**Addendum to the Costco Wholesale Project
Environmental Impact Report
SCH # 2011112025**

City of Ukiah
300 Seminary Ave
Ukiah, CA 95482

DUDEK
980 9th Street, Suite 1750
Sacramento, CA 95814
Contact: Brian Grattidge

NOVEMBER 2014

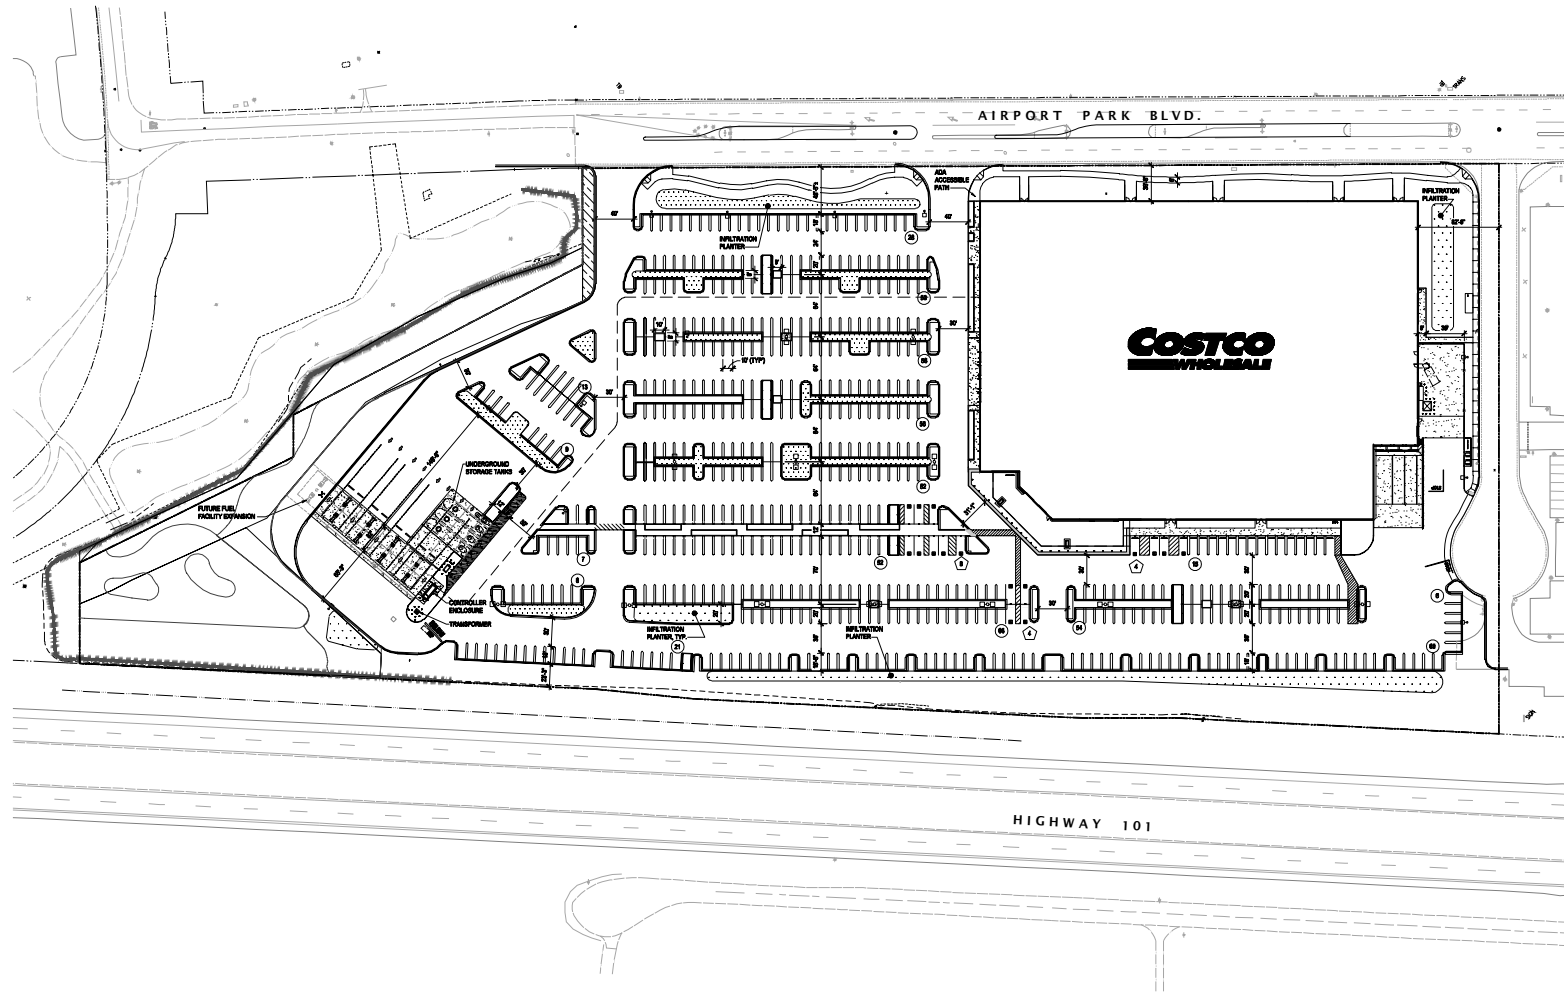
Final EIR Figure 2-3, Site Plan, has been replaced with the Revised Site Plan attached to this Addendum which reflects implementation of Mitigation Measure 3.6.4, as addressed below. The changes to the Site Plan, which are further described in Section 3.3, below, include identification of a buffer between the Project Site and the off-site wetlands, a detention basin, a change in the orientation of the fueling facility, a slight reduction in the size of the warehouse, a reduction in the size of the parking lot, additional bioswale areas, additional shade trees, and modification of the parking lot lighting.

A Final Drainage Plan has been submitted to the City and Regional Board as required. In order to accomplish the performance criteria of the Mitigation Measure, minor revisions to the Project Site Plan are required. Some of the key considerations in the development of the plan, and the resulting changes to the Site Plan (see Revised Site Plan), are described below:

2. Enhances habitat between the parking lot/fueling facility and the wetland. This is accomplished by rotating the fuel facility (see Revised Site Plan).

3. Reduces the amount of parking to accommodate the enhanced habitat and additional bioswales (see Revised Site Plan).
4. Rehabilitates the wetland area and the enhanced habitat and addresses on-site landscaping improvements by:

- e. Revising shrub planning to incorporate more California native species.
5. Decreases the size of the warehouse, from 148,000 SF to 141,000 SF.
6. Relocates and redesigns parking lot lighting to shield enhanced habitat area from potential lighting spillover (note that this change is also consistent with Mitigation Measure 3.1.2 regarding lighting spillover).

The rotation of the fueling facility does not adversely affect vehicular circulation on-site or pedestrian safety (see Revised Site Plan). However, it does accommodate the enhanced habitat between the Project and the adjacent wetland, while providing for a storm drainage system that meets the requirements of Mitigation Measure 3.64 and all storm water quality and volume standards.

The EIR assumes a maximum warehouse size of 148,000 SF. In order to better accommodate the enhanced habitat area, the drainage plan and the associated changes to the Site Plan, the warehouse size has been reduced by approximately 5%, to 141,125 SF. As the impact analysis in the EIR assumes the larger building size, all Project impacts for the 141,125 SF warehouse would be either the same or slightly less than those identified in the certified Final EIR. The reduced parking still meets City parking standards for the smaller warehouse, and in fact addresses public concerns raised during the Project hearings that the Project was over-parked. The Site Plan approved on January 22, 2014, provided for 607 parking spaces. This amount of parking exceeded the 592 spaces required by the City's development code, based on a 148,000 SF warehouse. The Revised Site Plan (Figure 2-3) includes a 141,125 SF warehouse and 579 spaces. The 579 proposed parking spaces meet the minimum parking requirement of 565, based on a 141,125 SF building.

The previous Site Plan (Final EIR Figure 2-3) was approved by the City Planning Commission as part of the Site Development Permit on January 22, 2014. The City has determined that the minor changes to the Project Site Plan (see Figure 2-3, Revised Site Plan) are in substantial conformance with the Project Site Plan approved by the Planning Commission and, therefore, do not require an amendment to the Site Development Permit or further Planning Commission review, although the modification of the Site Plan is subject to City approval and, as a discretionary action, is subject to CEQA.
